STAFF REPORT
COMMUNITY DEVELOPMENT DEPARTMENT

HEARING DATE: December 15, 2020

SUBJECT: H-2020-0092
Goddard Creek Community

LOCATION: Northwest corner of W. McMillan Rd.
and N. Goddard Creek Way.

B. Preliminary Plat (date: 9/2/2020)

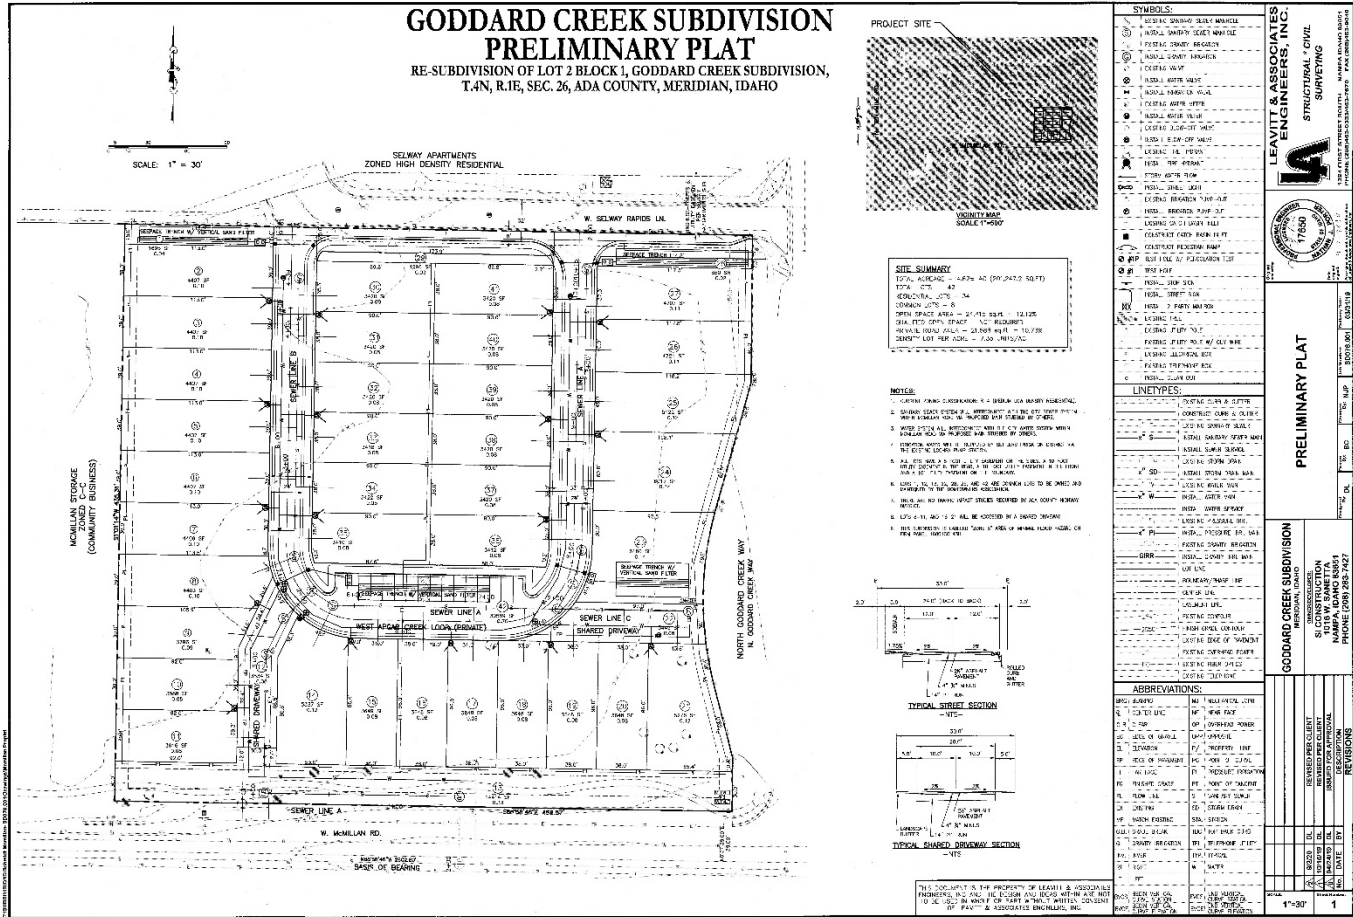
2. The preliminary plat included in Section VII.B, dated 9/2/2020 shall be revised as follows at least ten (10) days prior to the City Council hearing:

- a. Depict zero lot lines on those lots that have shared walls.
 - b. Clearly depict all pedestrian connections within the development on the plat, specifically the pedestrian connection adjacent to the common drive/emergency access (Lot 12).

- c. Add a sidewalk connection within Lot 1 that continues the sidewalk on the west side of N. Selway Falls Lane.
 - d. Show all pedestrian crossings as pavers, stamped concrete, or similar to clearly delineate pedestrian connections and provide Staff a pedestrian exhibit that shows this and shows a cross-section of the crosswalks.

C. Landscape Plan (date: 9/2/2020)

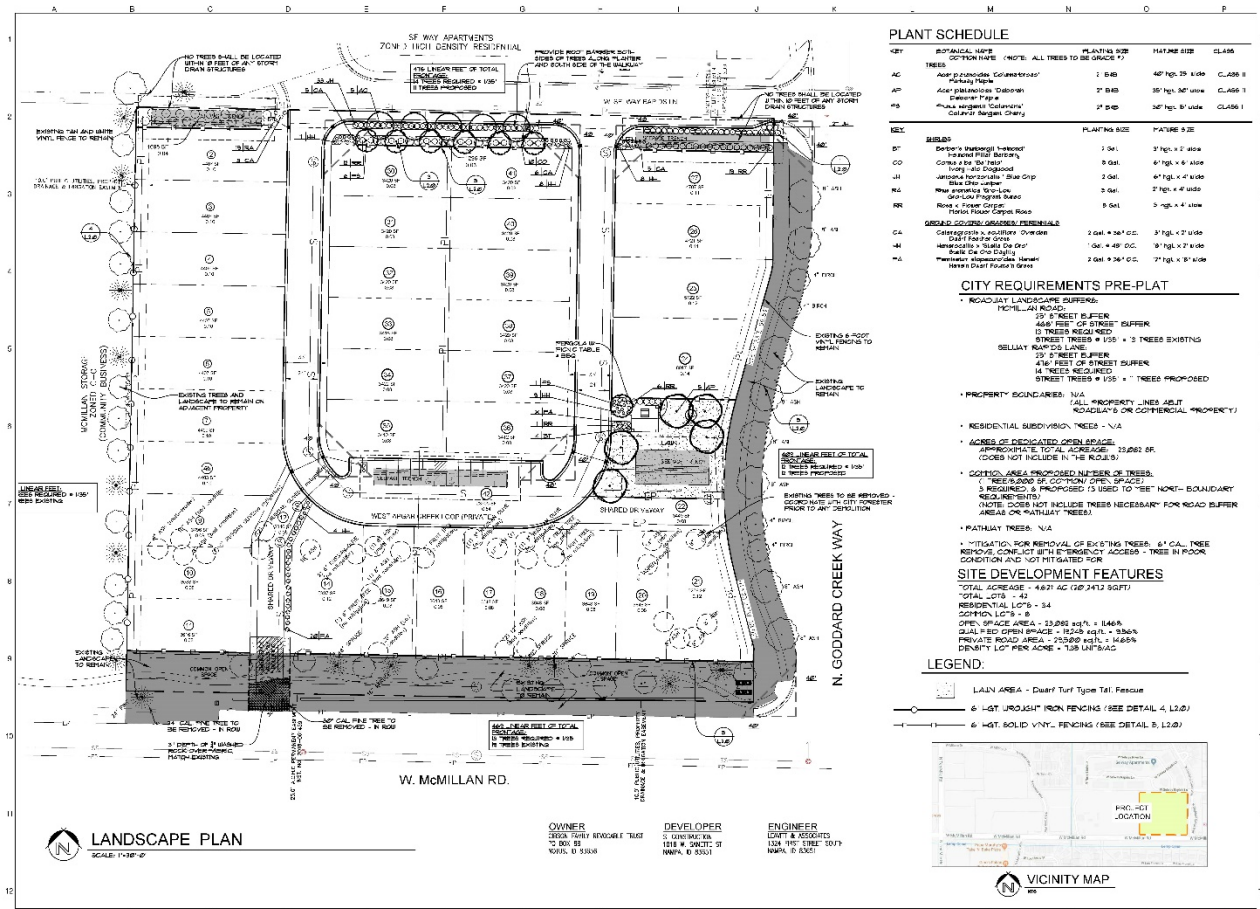
2. The landscape plan included in Section VII.C, dated 10/18/19 shall be revised as follows:
 - a. Provide the details of the site amenities with the submittal of the final plat application.
